HISTORIC AND DESIGN REVIEW COMMISSION

November 01, 2017

HDRC CASE NO: 2017-538
ADDRESS: 8314 S PRESA ST
LEGAL DESCRIPTION: NCB 10923 BLK LOT TR 1 & TR 2
ZONING: R-6 H
CITY COUNCIL DIST.: 3
DISTRICT: Mission Historic District
APPLICANT: Eduardo Villalon, P.E./San Antonio River Authority
OWNER: San Antonio River Authority
TYPE OF WORK: Construction of a hike and bike trail
APPLICATION RECEIVED: October 13, 2017
60-DAY REVIEW: December 12, 2017
REQUEST:

The applicant is requesting a Certificate of Appropriateness for approval to construct a multiuse pedestrian trail to span approximately 0.22 miles in length. The trail will be constructed of concrete paving. The proposal includes a canopy shade structure to cover a picnic area, tree removal and new landscaping, directional signage, trash receptacles, and a pedestrian bridge.

SHEET
 C15 OF 18

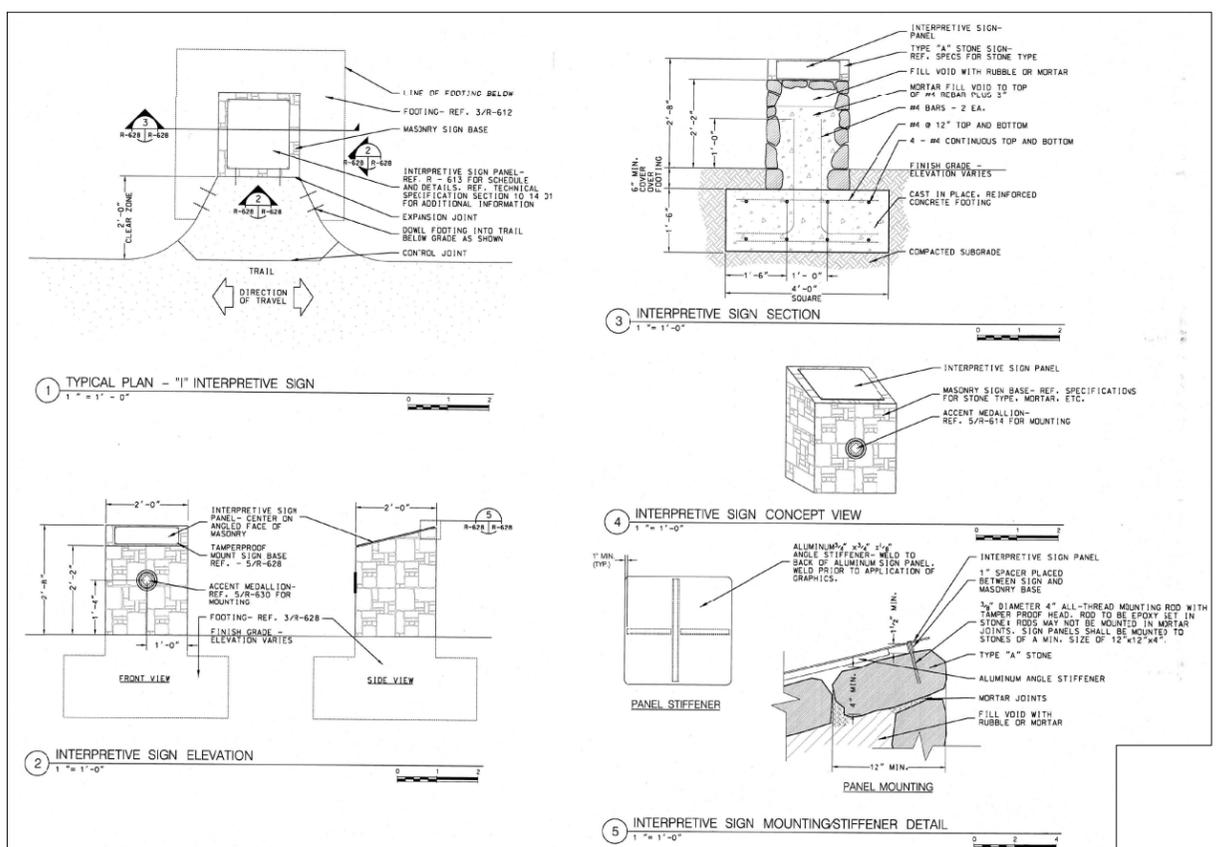
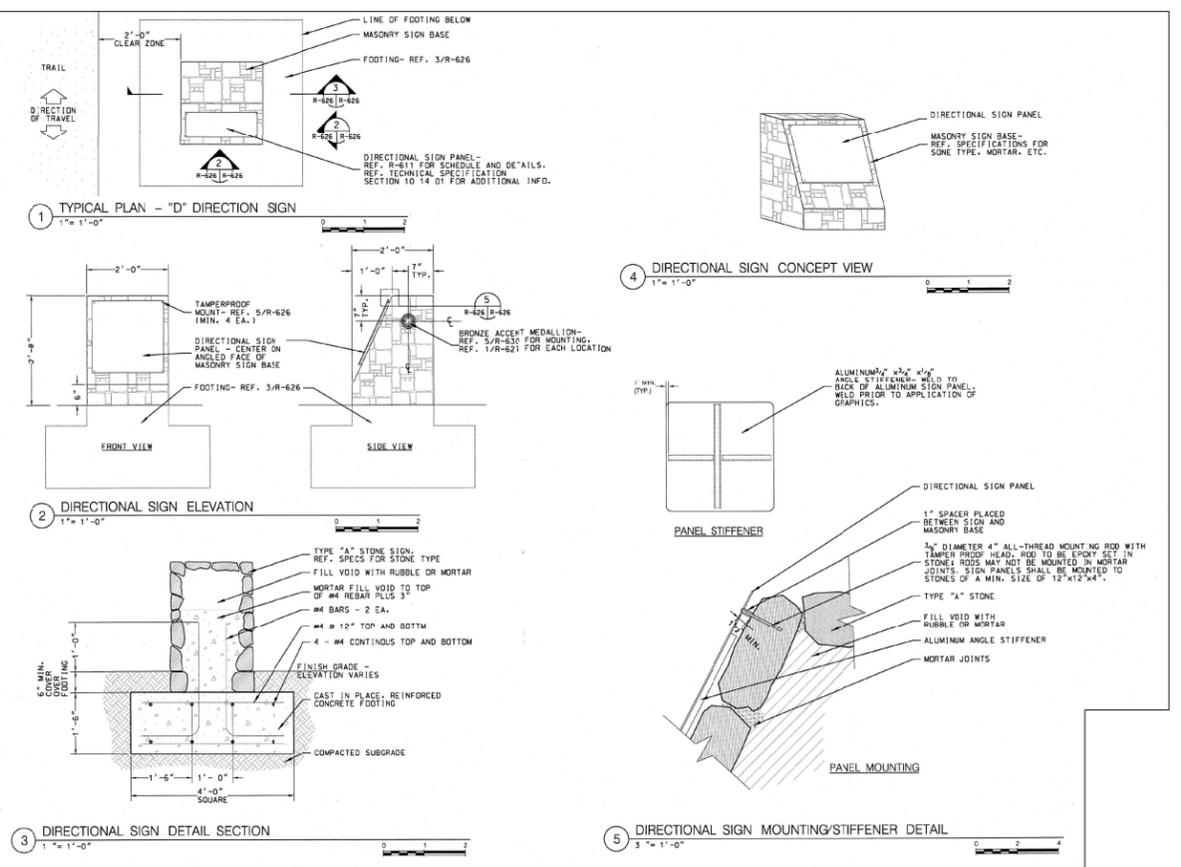
- e. TRASH RECEPTICLES –According to the UDC, receptacles should blend visually with their surroundings and their design and location should make use as convenient as possible. The proposed receptacle designs are conveniently located at trail focal points and compatible with both the proposed built and existing natural environment. Staff finds the placement and design appropriate.

- f. DIRECTIONAL SIGNAGE – The applicant has proposed to install directional signs throughout the trail that are to be non-illuminated and constructed of masonry, bronze accent medallions, and informational signage panels. The signs will feature an overall height of either approximately 2’-8” with a width of approximately 2’-0”. According to the UDC, primary sign design considerations shall be identification and legibility. Size, scale,

BROOKS CITY BASE CONNECTION
SUN SHADE PLANS AND SECTIONS

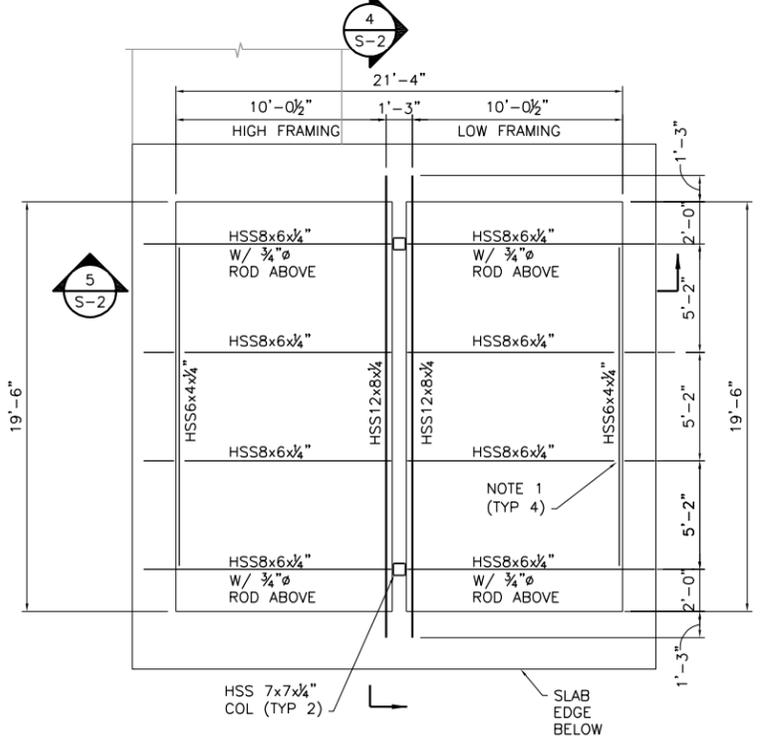
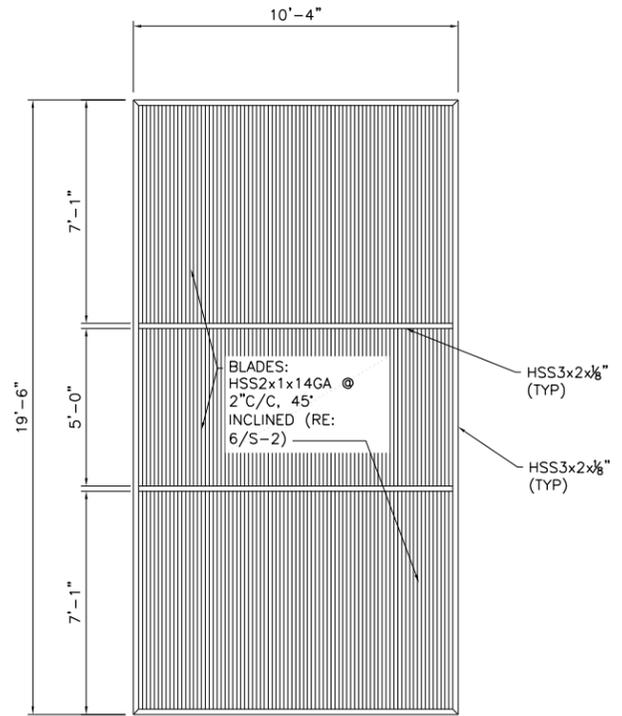
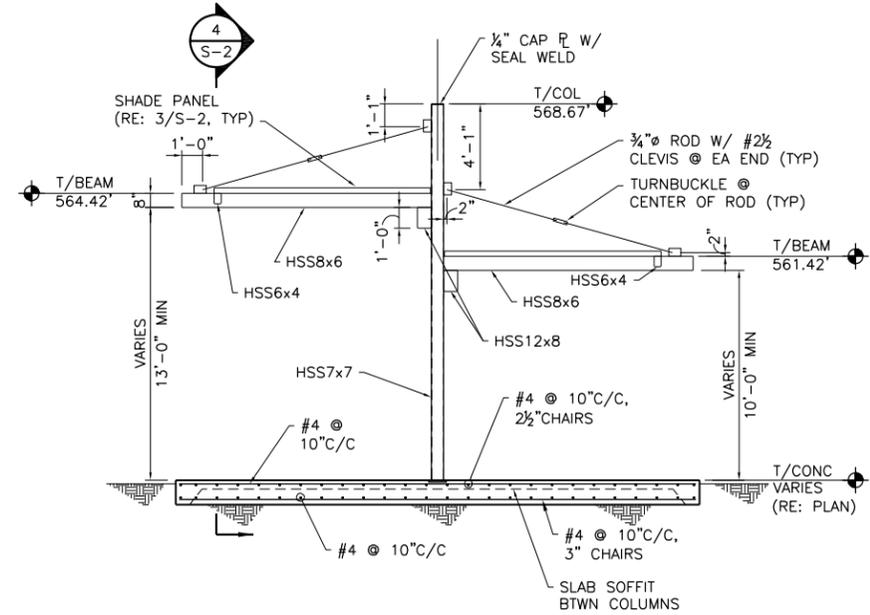
- c. SHADE STRUCTURE – The applicant has proposed to install a canopy shade structure to cover a picnic area. The structure will be constructed of metal support columns and a metal roof canopy structure. The shade structure canopy and structure will be painted in the shade Old Copper as indicated in the exhibits. Staff finds the size, design, materiality, color appropriate for the structure’s setting and purpose.

- d. SEATING – The applicant has proposed to install several picnic tables for seating beneath the shade structure. According to the UDC, seating should be physically comfortable and inviting, durable and attractive. Staff finds the proposal appropriate.
